IMPORTANT SAFETY RECALL

NHTSA Recall No. 24V-740

Terex Utilities

SUBJECT: Jib Extension Cylinder Rod Weld

Figure 1. Load Line Hook Secured to Anchor on Main Jib Boom

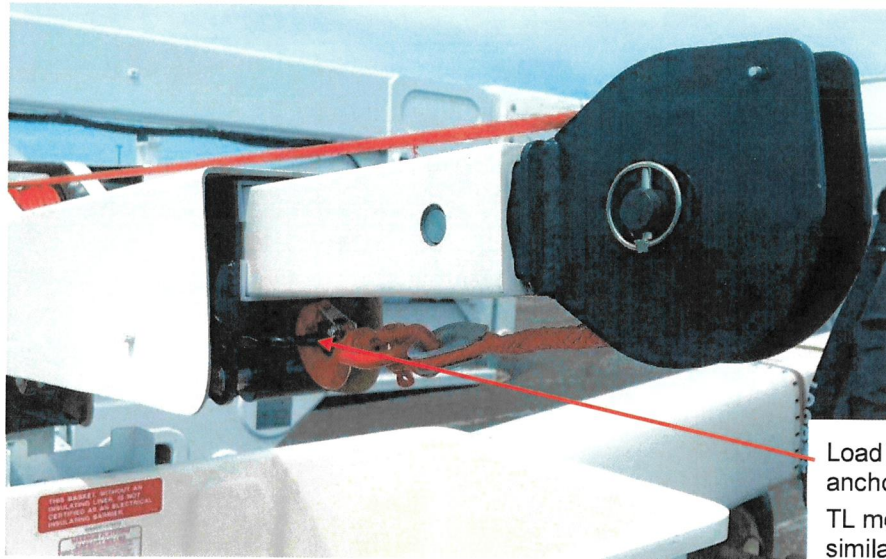
1. Always follow the inspection and maintenance requirements as specified in the manuals.
2. Ensure the jib extend hydraulic cylinder is at or above horizontal when loaded.
3. Secure the load line hook when stowing the machine as shown in Figure 1 below.

Figure 2. Included – Certain Top Mount Jib Assemblies

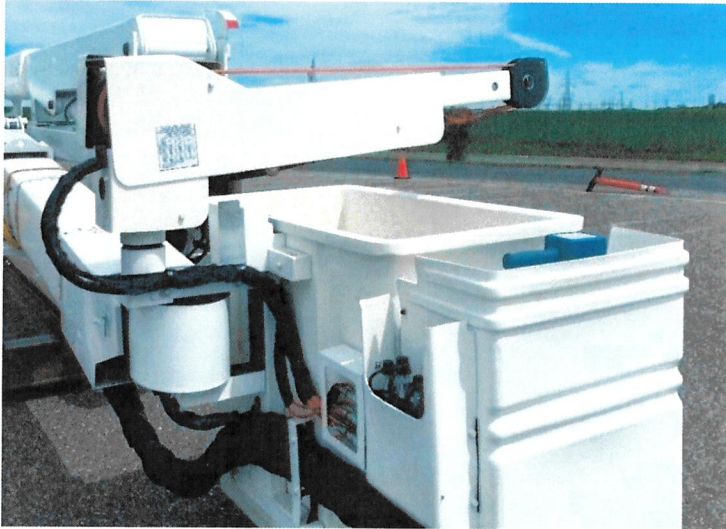
1. Deploy the outriggers and position the booms in the ground mount position clear of any obstacles. For the TM, position with the lower boom fully articulated and the upper boom articulated and extended so the basket is near the ground. For the TL80, TL80/112, and TL100, position with the lower boom raised to approximately 20 degrees, upper boom fully lowered and extended.
2. Visually inspect the jib assembly to determine if the jib assembly is affected using the Figures below as reference. Included are certain top mounted jibs, Figure 2.

Figure 3. Excluded – Dual Basket with Side Mount Jib Assembly

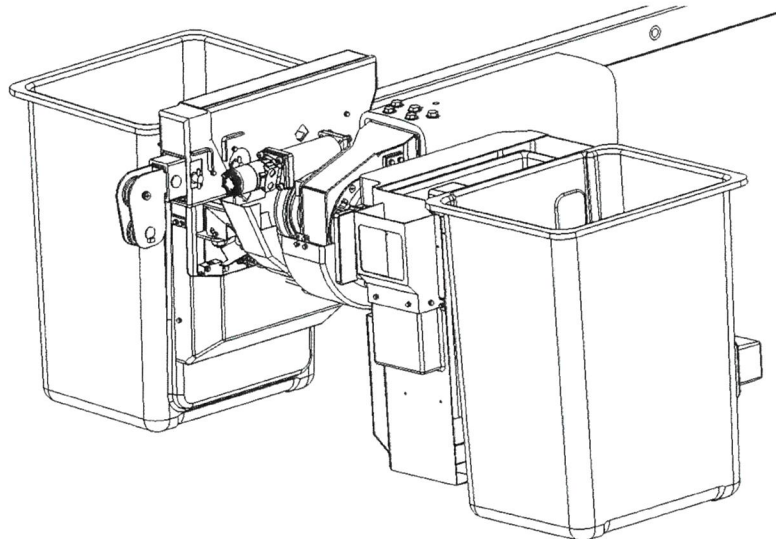
Excluded are dual basket machines where the jib is between the baskets, Figure 3, and single 2-man baskets with side mount jibs, Figure 4.

Figure 5. Location of Jib Extension Cylinder

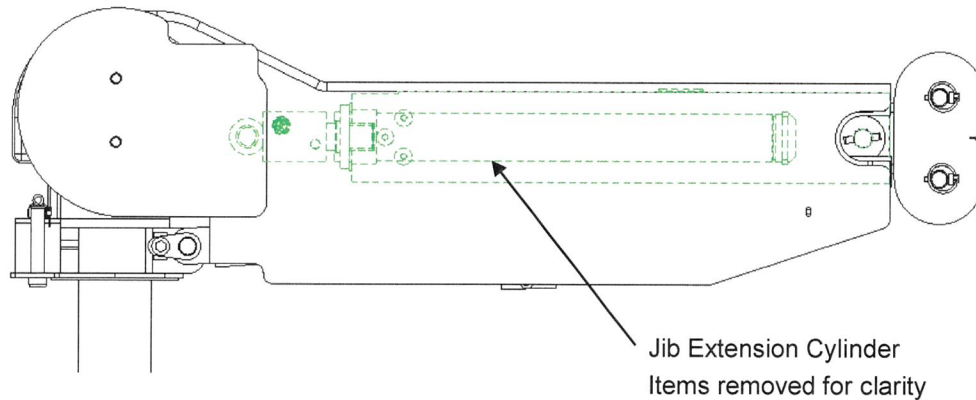
3. Locate the jib extension hydraulic cylinder, using Figure 5 below as reference.

Figure 6. Example Hydraulic Cylinder Date Code

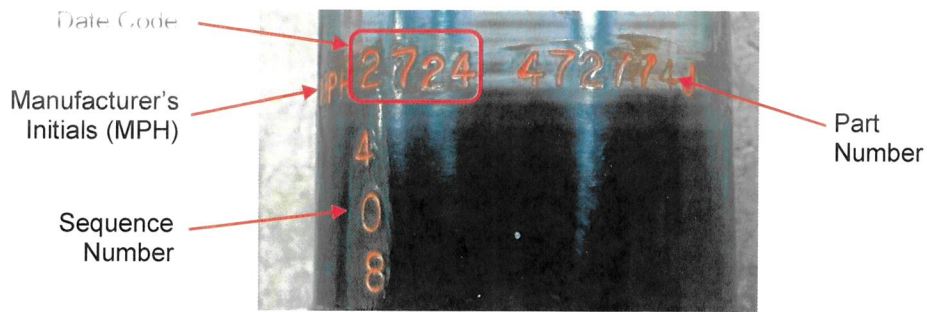
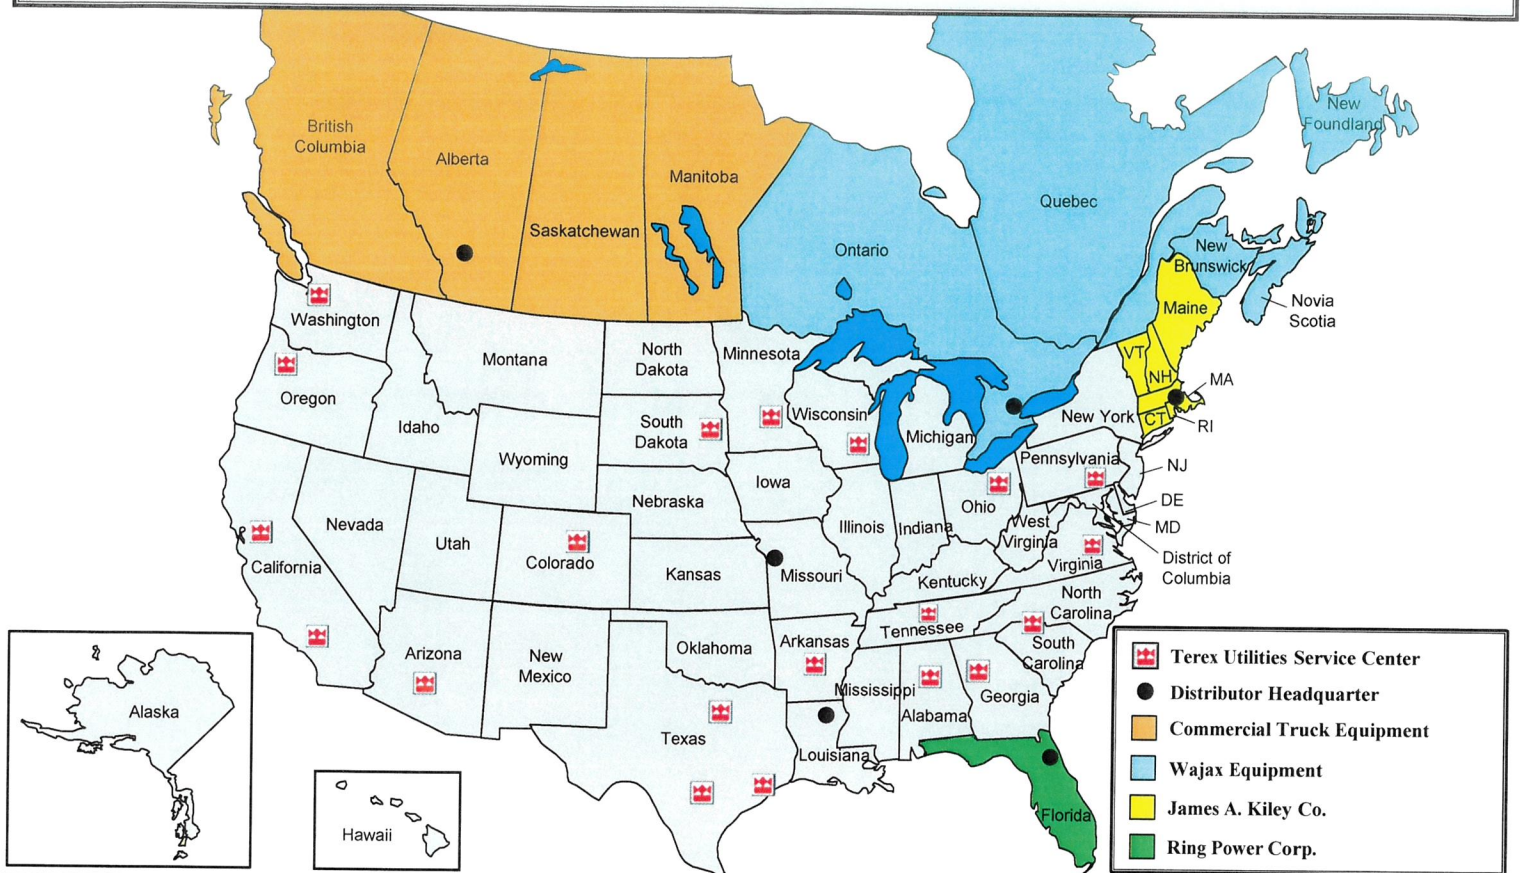
4. Remove covers as needed and remove the jib extend hydraulic cylinder following the instructions in the Maintenance Manual of your machine.
5. Using Figure 6, inspect the part number and date code on the hydraulic cylinder. The first two numbers in the date code are the week the cylinder was manufactured. The second two numbers are the year the cylinder was manufactured. The example below was manufactured week 27 in 2024. Sequence number 408 represents this was the 408th cylinder manufactured in week 27 in 2024.

6. Any MPH hydraulic cylinder with part number 472774 and date codes and sequence numbers shown in the table below stamped in the case is subject to the recall and will need the hydraulic cylinder replaced.

7. Any MPH hydraulic cylinder with part number 472774 stamped in the case that does not fall in the above date code and sequence number combination is not subject to the recall and can continue to be used.
